Gainesville Renewable Energy Center Completeness Responses and Amendment to the Site Certification Application

Re: Gainesville Renewable Energy Center
Site Certification Application (PPSA No. PA09-55)
Completeness Responses and Amendment to the Site Certification Application

The completeness responses are provided in response to the Florida Department of Environmental Protection (FDEP) Determination that Application is Incomplete dated January 11, 2010. The responses provide additional information and clarifications to the requests from the reviewing agencies, which were included with FDEP's determination of incompleteness. For certain agency requests, GREC LLC clearly indicates the reasons why the requested information is not provided. Also, as indicated in several of the responses, GREC LLC has concluded that certain completeness items may be more suitably addressed through postcertification submittals and has recommended conditions of certification for several of these requests.

TIE TO C2.03 (SHEET 1 of 3)

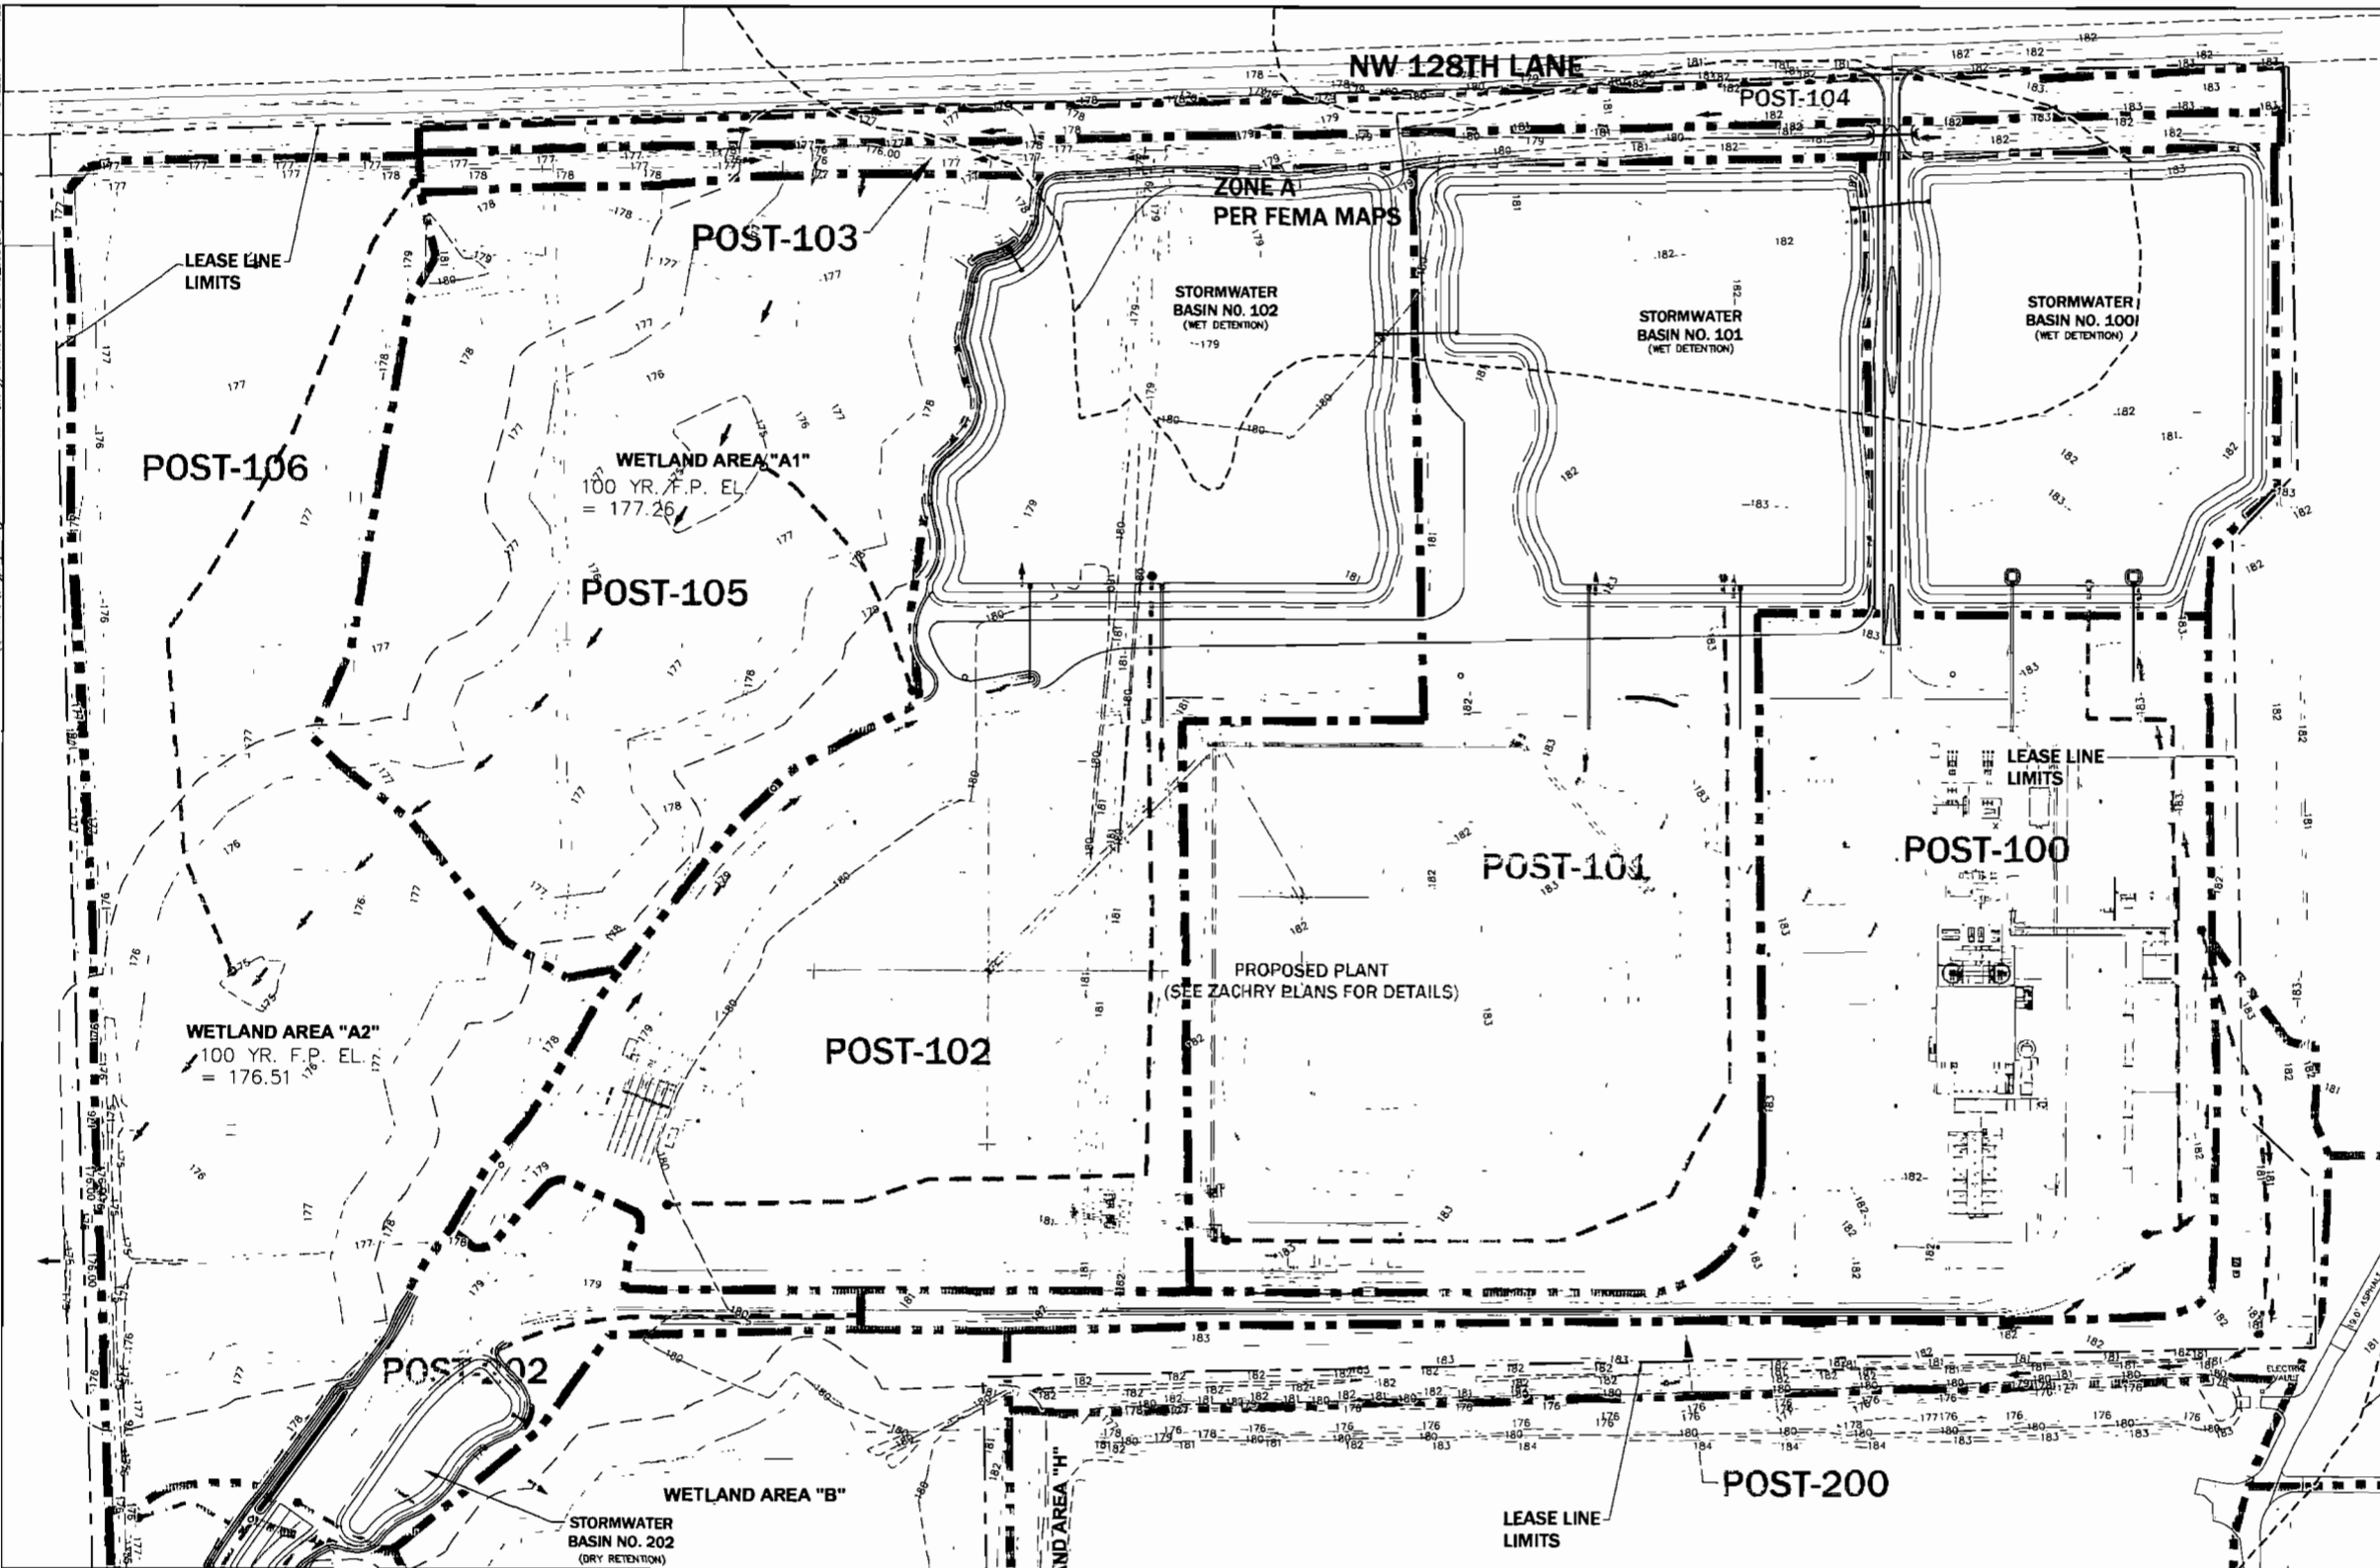
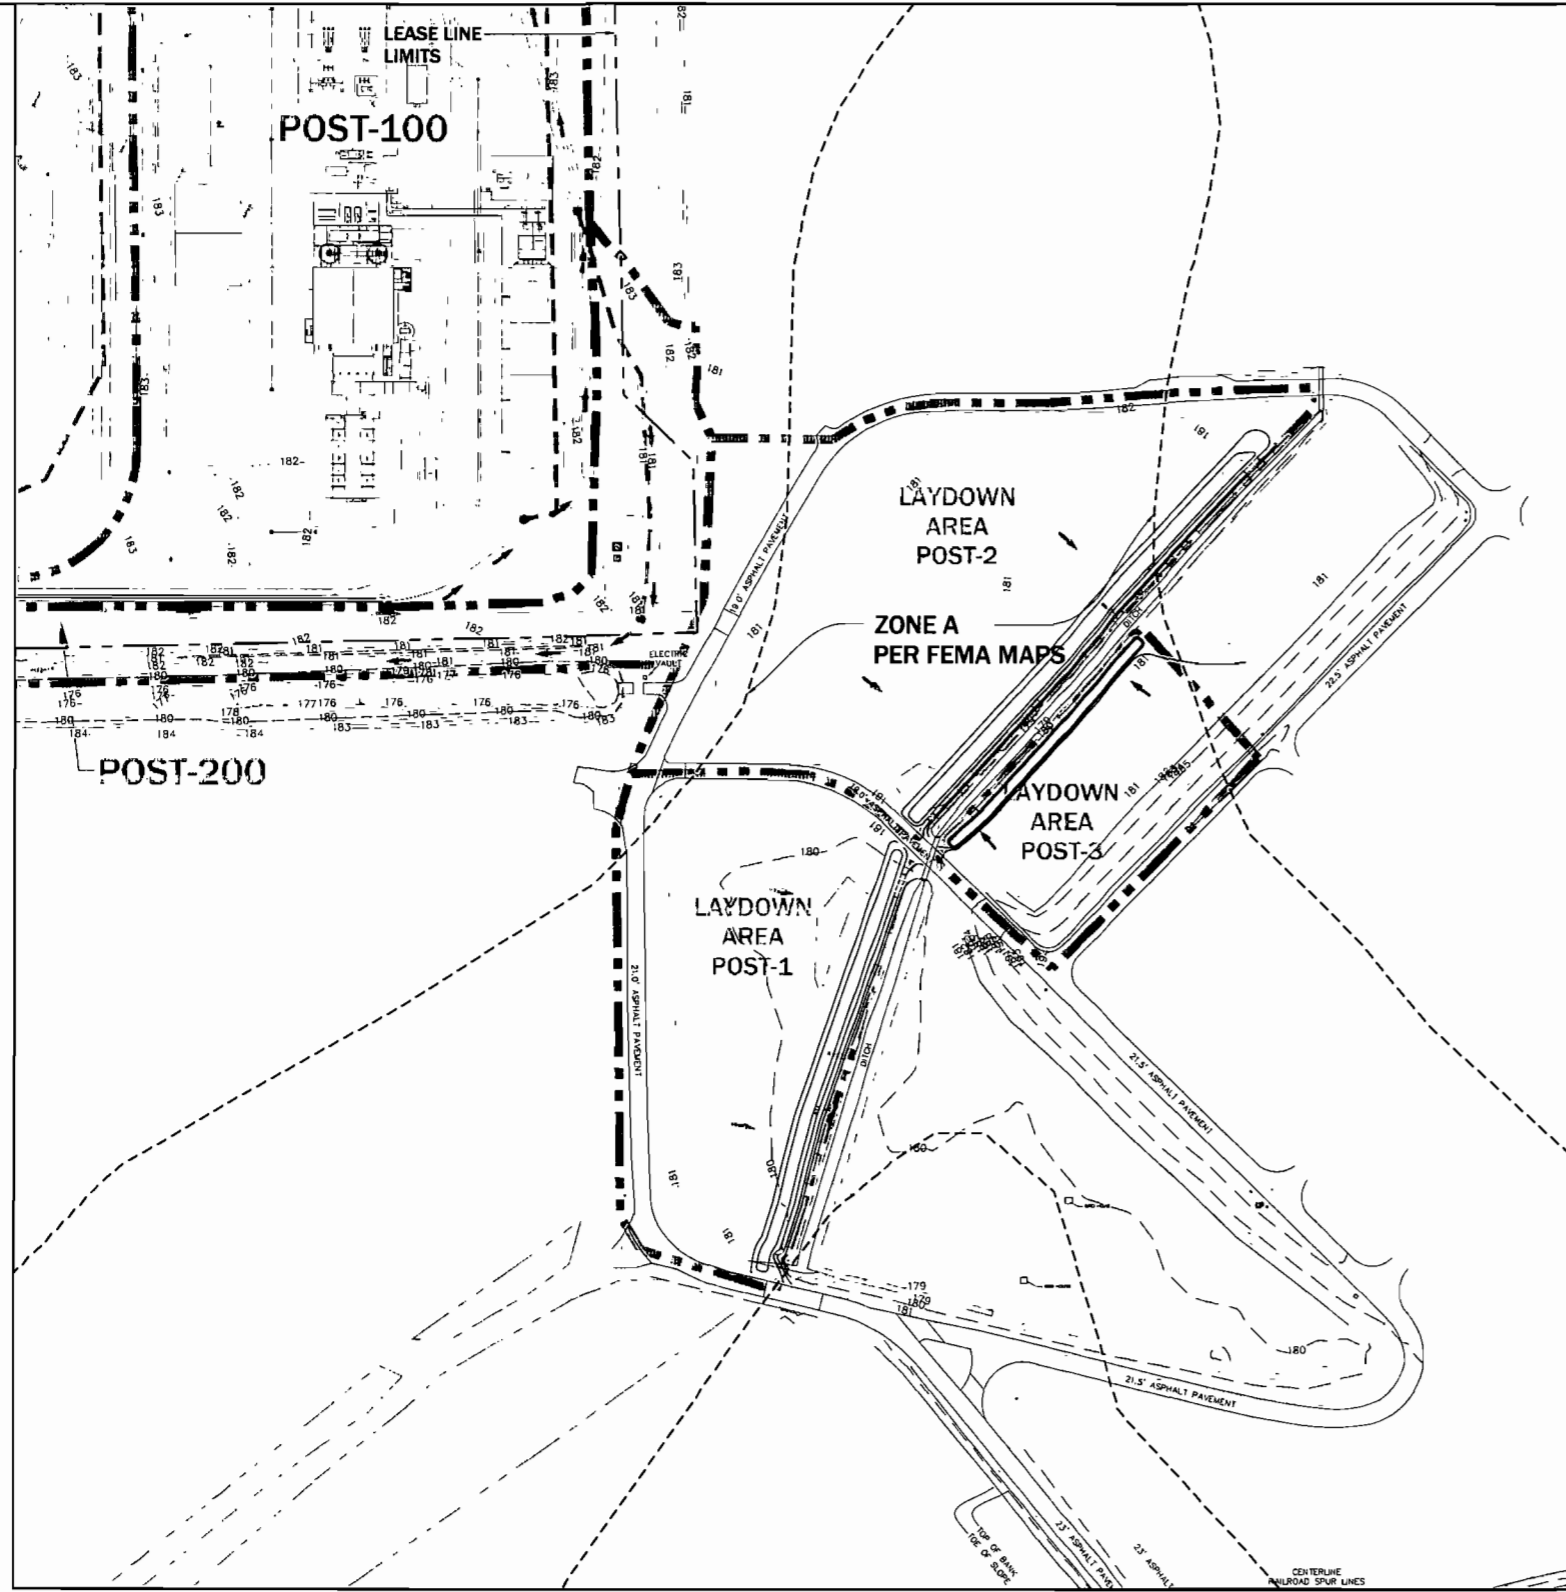
FDEPNEDSW-1 1) Contour lines in the Pre- and Post-development Drainage Maps, Sheets 1 and 2 of 2, found in Volume 2, Appendix 10.4.2, are labeled incorrectly. Please revise.

Referenced datum is North American vertical datum of 1988 (NAVD88) as shown in the notes in the boundary and topographic survey plan, sheet 1 of 5 in Attachment B to this document.

Conveyance of runoff into the proposed stormwater systems is shown in the grading plans (see sheets C2.20, C2.21, and C2.22 in Attachment B). These drawings are also included in the attached CD (stormwater management plan).
